FCC Class II Permissive Change Application Letter

Product name : 7 TABLET PC ANDROID

FCC ID: 2AAC3F7UHDX

Model No.: F7UHDX

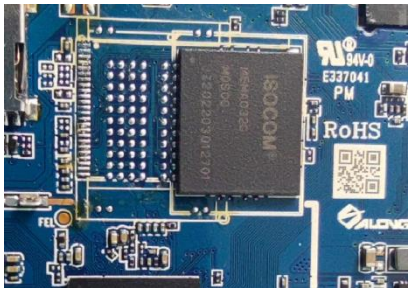
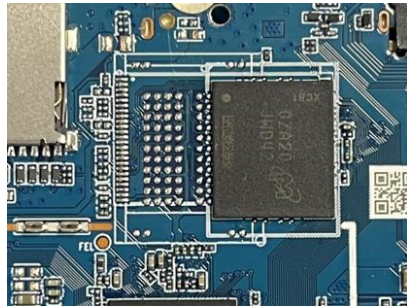
Change Contents: update the PCB as below:

Location	Original equipment of FCC ID: 2AAC3F7UHDX	New equipment of FCC ID: 2AAC3F7UHDX
Main board		
	Replace the EMMC IC; Original equipment is 32GB, New equipment is 64GB The new chip component is pin-for-pin compatible; No change in radio parameters has occurred.	
Model No.	F7UHDX	F7UHDV
System	LINSAY_F7UHDX_a133_android12_b6_SMR_user_wihota 20220819	LINSAY_F7UHDV_V1.0_20230527
Added SAR testing to ensure the equipment meets the FCC portable device requirements. Modifications that do not change the fundamental RF characteristics and that do not degrade the unwanted emissions of the certified product; Modifications that do not change physical characteristics significantly. We attach new photographs to identify the modified product.
